PHILIP WILLIAMS & ASSOCIATES

MEMORANDUM

RE: **Technical Review and Comments on the City of St. Helena Comprehensive Flood Protection Project Draft EIR¹**
PWA Ref. #: 1628.01

Table 1. Results of HEC-RAS Sensitivity Analysis¹ (continued)

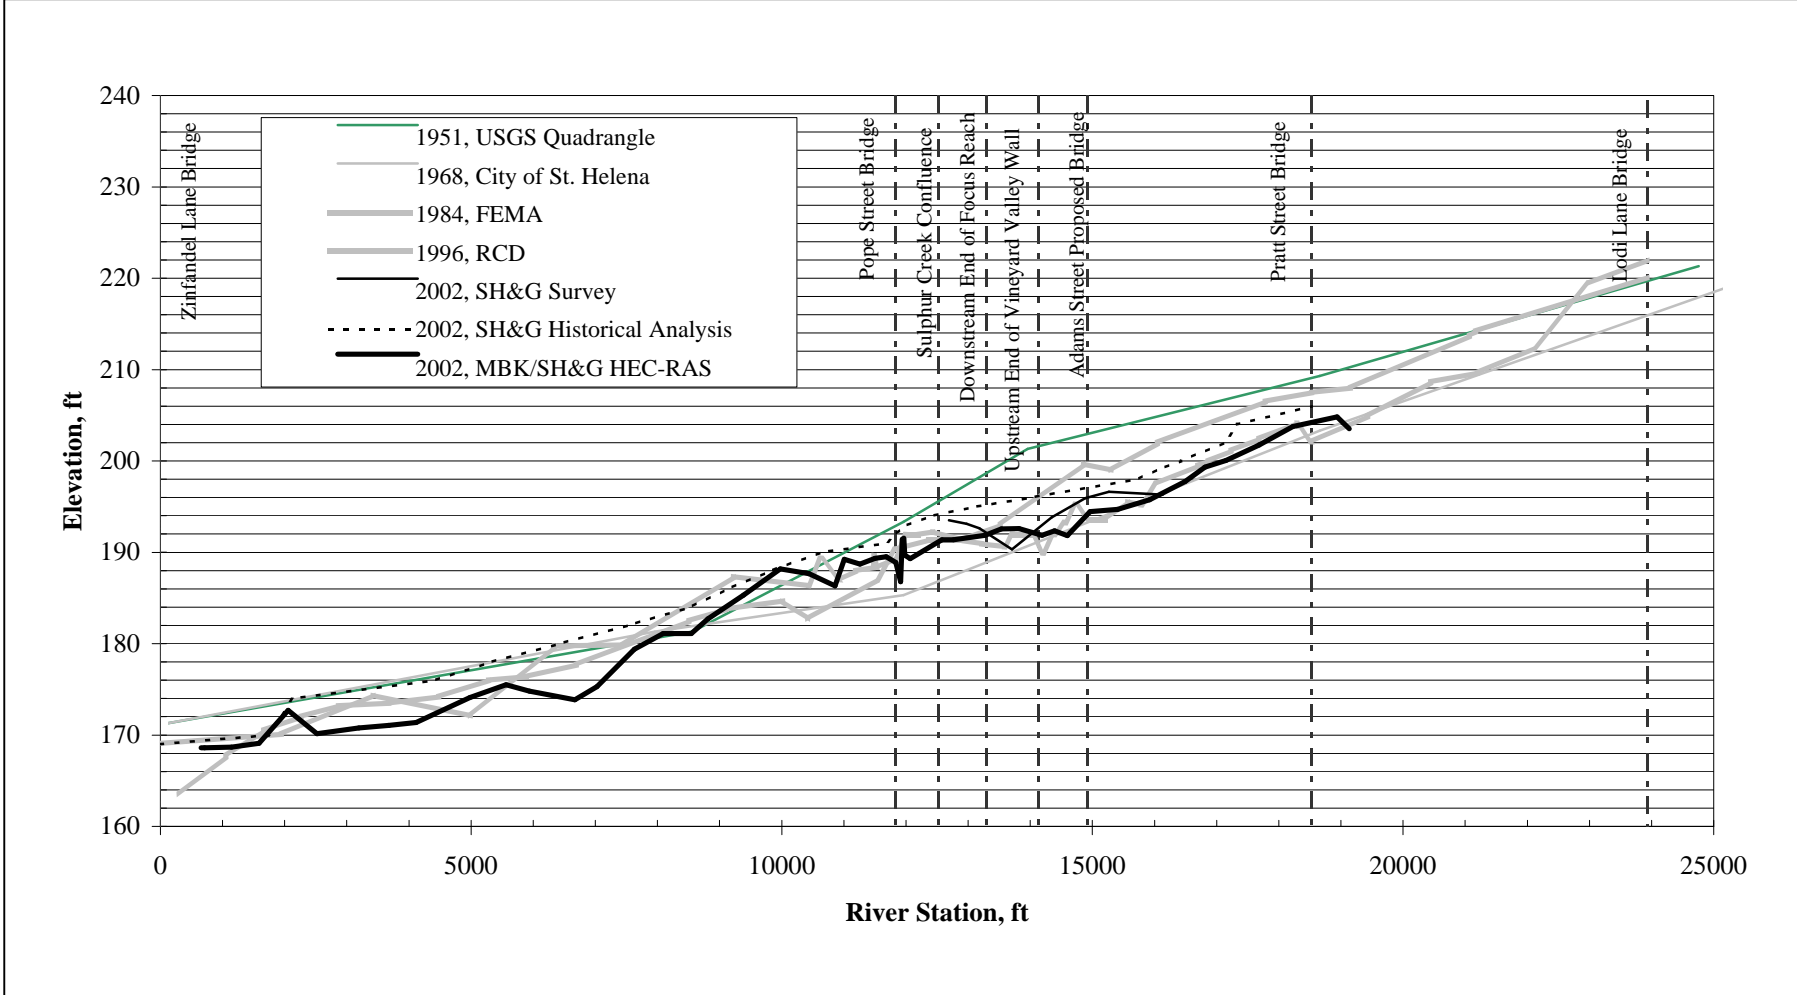
PWA conducted a preliminary sensitivity analysis of the EMP model to sedimentation, vegetation growth and bridge obstruction. Effects on water surface elevations for these different scenarios are summarized in Table 1.

Sedimentation or aggradation of the main river channel was discussed under 1) above. Briefly, aggradation to higher, 1984 bed conditions impacted the reach upstream of the project focus reach, near Pratt Avenue. Sedimentation in the overflow channels was also previously discussed under 2) above. The effect of 2 feet of sedimentation in the designed EMP overflow channels had minor effects on the water surface elevation, raising water surfaces up to 0.2 ft in the project reach.

Of all of the scenarios we modeled, the EMP appears most sensitive to increases in downstream roughness. Management decisions/practices in this adjacent reach (for about ¾ mile downstream of Pope St bridge) are critical to the success or failure of the EMP. Roughness values in this downstream reach were calibrated to much lower values than found in the project reach (n~ 0.048-channel/0.06-overbank). We tested the effect of increasing roughness in this reach to levels found under existing conditions upstream, in the project focus reach (n~0.075-channel/0.09-overbank). The resulting increase in water surface elevations is substantial. Water surfaces increase up to 1.7 ft near Pope St bridge, and 0.9 ft at the downstream end of the focus reach. Figure 3 compares the resulting water surface profile to the EMP and Existing conditions model results.

The obstruction of Pope Street Bridge was modeled for two cases: debris obstruction and bridge skew. For bridge skew, we followed Federal Highway Administration guidelines for estimating the reduction of bridge capacity due to skewed entrance flows relative to bridge piers. The Napa River enters the Pope Street bridge after completing a large meander that curves westward. Increasingly, this meander bend is eroding the outside bank, while the inside gravel bar is building out into the channel centerline. While this is a natural process, it is countered by maintenance of bank protection on the right bank and vegetation/sediment removal on the left bank point bar. Using aerial photographs reported in the DEIR (Figure 3-5), we estimated that the angle of approach of the River to the Pope bridge can vary up to 18.9° from normal to the bridge deck. Using Federal Highway Administration guidelines (Bradley, 1978), there is a resulting reduction in bridge capacity of approximately 25%. When incorporated into the model, bridge skew effects raise water surface elevations from Pope St upstream of the proposed Adams St bridge, up to 0.4 feet in the 100-year event. In addition, PWA examined a bridge obstruction from debris using the Sonoma County Water Agency Flood Control Design Criteria, which require an allowance of 2-feet of debris obstruction on either side of bridge piers (SCWA, 1983). The result is a 10% reduction in the capacity of Pope St Bridge. This results in minor increases in water surface elevation of up to 0.1 ft.

Combined effects of vegetation growth (in overflow channels), sedimentation in overflow channels and streambed (2ft), and a minor bridge obstruction due to debris blockage (10% reduction), are slightly greater than for vegetation growth (in overflow channels) alone. In this scenario, all anticipated EMP flood reduction benefit would be eliminated.

figure 1

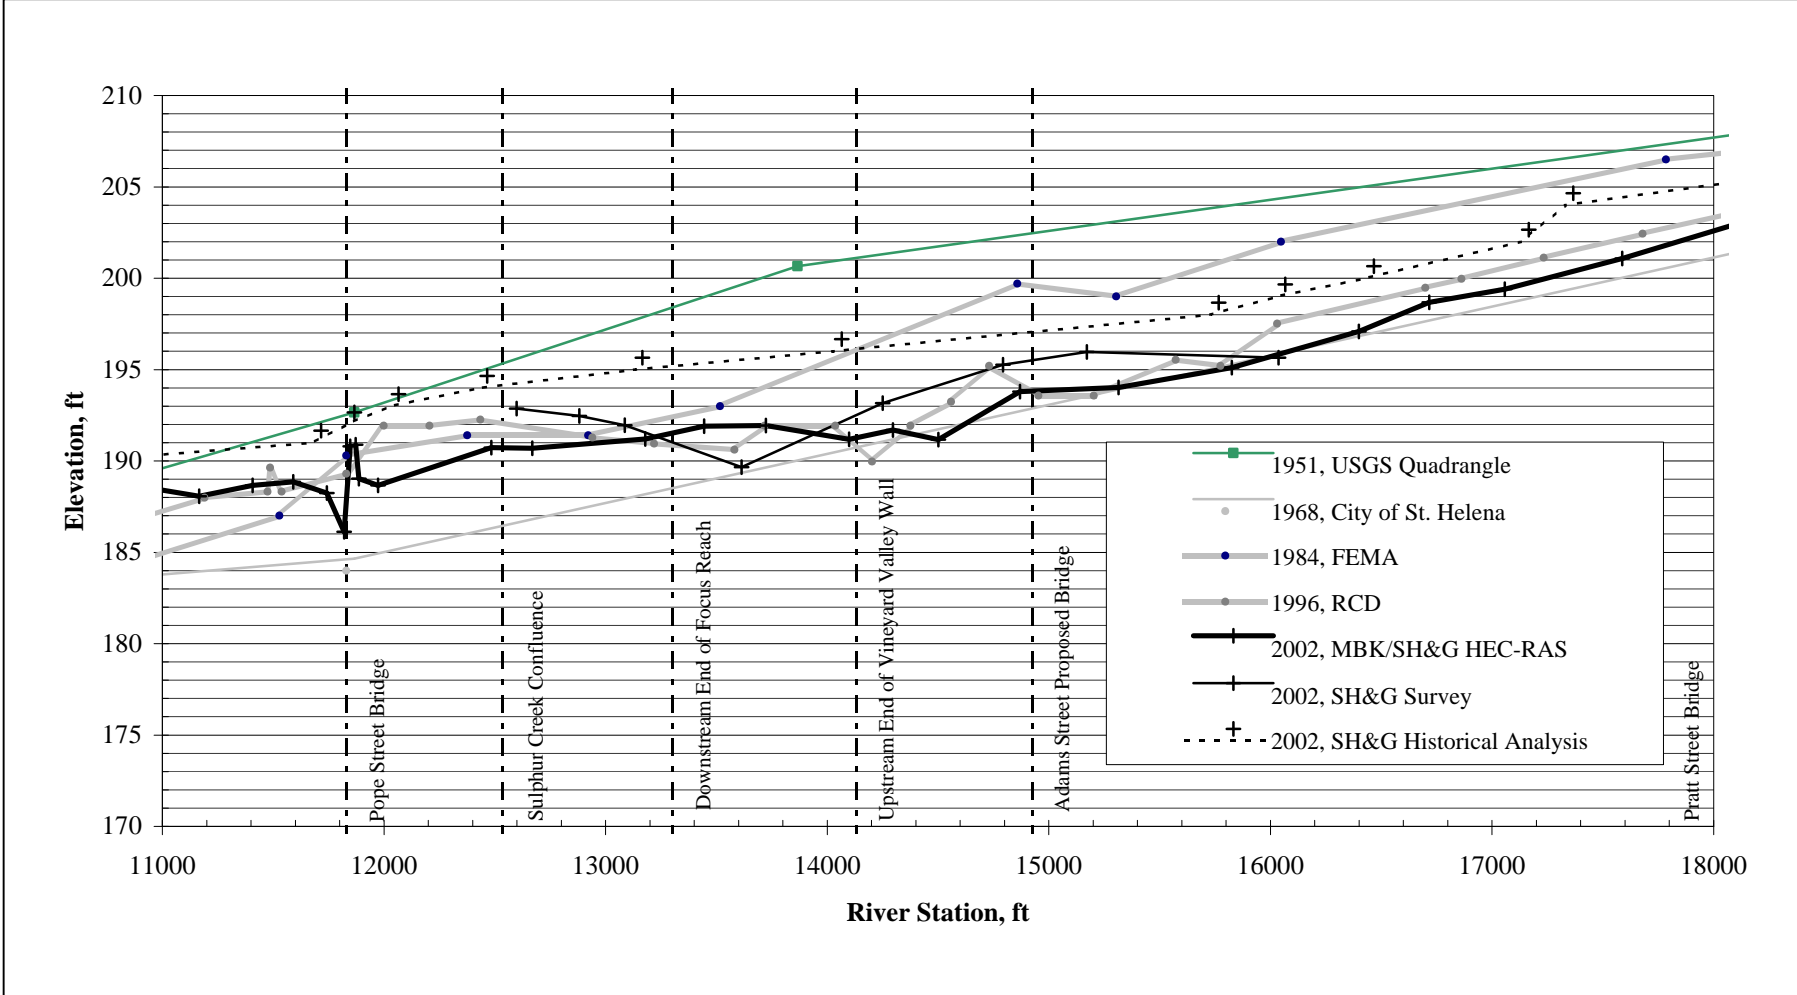
To further examine the issue of the Napa River's vertical stability, we plotted a series of 8 historic profiles dating from 5 years: 1951, 1968, 1984, 1996, and 2002 (three profiles). The profiles are shown in Figures 1 and 2, for the project and focus reaches. Before analyzing the profiles, it should be noted that the profiles come from sources of varying accuracy and quality. The 1951 and 1968 profiles are from SHG's 2003 report, Figure 16. SHG cited sources of these profiles as the City of St. Helena (1968) and USGS quadrangle map (1951); we presume that these profiles were estimated from contour lines on large scale maps, which probably did not include survey data in the river channel. Therefore, the application of these surveys for channel profile analysis is questionable. The 1984 profile from the 1998 FEMA FIS is presumed accurate, but its accuracy is not certain. The 1996 RCD profile is based on field survey data, which was tied into a known datum using County and USGS benchmarks, is also presumed accurate. The accuracy of the 2002 SHG Historical Analysis profile from 2-ft aerial survey contours is questionable because it is markedly different from the other two 2002 profiles. The "2002 SHG Survey" profile is from a ground survey of cross-sections, and is presumably accurate. Finally, the 2002 MBK/SHG HEC-RAS profile is from February/April 2002 surveys (pers. comm. Mark Fortner, MBK) and is presumed accurate. As stated in our previous comments, and plainly visible in Figures 1 and 2, three significantly

different 2002 longitudinal profiles were used as a basis for the analysis and design. The three profiles appear in Figure 16, 20 and Appendix A in the SHG 2003 report, and are plotted here in Figures 1 and 2 as the dashed, thick and thin black lines, respectively. Since different conclusions can be drawn depending on which 2002 profile is used, it is essential that the study team establishes which of the surveys is the most accurate and adopts that as the base for project studies. In the meantime, we have adopted the 2002 MBK/SHG HEC-RAS profile, as the most complete and accurate of the three 2002 surveys for our analysis, below.

To the extent that the 1984 FEMA profile is accurate, a comparison of the 1984, 1996 and 2002 HEC-RAS profiles suggests that the Napa River has been in a downcutting phase over the last 18 years. Between 1984 and 2002, the River downcut up to 7 feet between Pope and Pratt Street, averaging approximately 4.2 ft of incision over this reach. One exception is that from Sulphur Creek downstream to Pope Street bridge, the channel aggraded between 1984 and 1996 and subsequently downcut between 1996 and 2002. In general though, the overall trend appears to one of incision in this reach. It is also noteworthy that incision downstream of Pope Street appears to have been occurring more recently, with most incision occurring between 1996 and 2002. This is contradictory to SHG's finding that the Napa River profile is in a stable, "dynamic equilibrium" in the project reach, based on the assumed accuracy of the 1951, 1968 and "2002 Historical Analysis" profiles. The amplitude of "dynamic equilibrium," of up to >10 feet in this reach, indicates that the channel may not be classified as stable.

The consistency of the Napa River bed elevation at Pope Street in the 1984, 1996, and 2002 profiles lends support to our observation of a rock sill that acts as a grade control at the bridge. The Limiting Factors Analysis for Napa River Basin also confirms the existence of this sill, which is mapped as a potential fish barrier in Map 12 (Stillwater Sciences, 2000). We maintain that the River has the potential to downcut at the Pope Street bridge if the artificial rock/concrete sill is not maintained. Maintenance of this sill has not been included as a criterion of the EMP. Consequences of a blowout of the sill could have devastating effects on the project and riparian habitat, including undercutting banks and bank protection, potentially causing mass bank failures and loss of riparian vegetation.
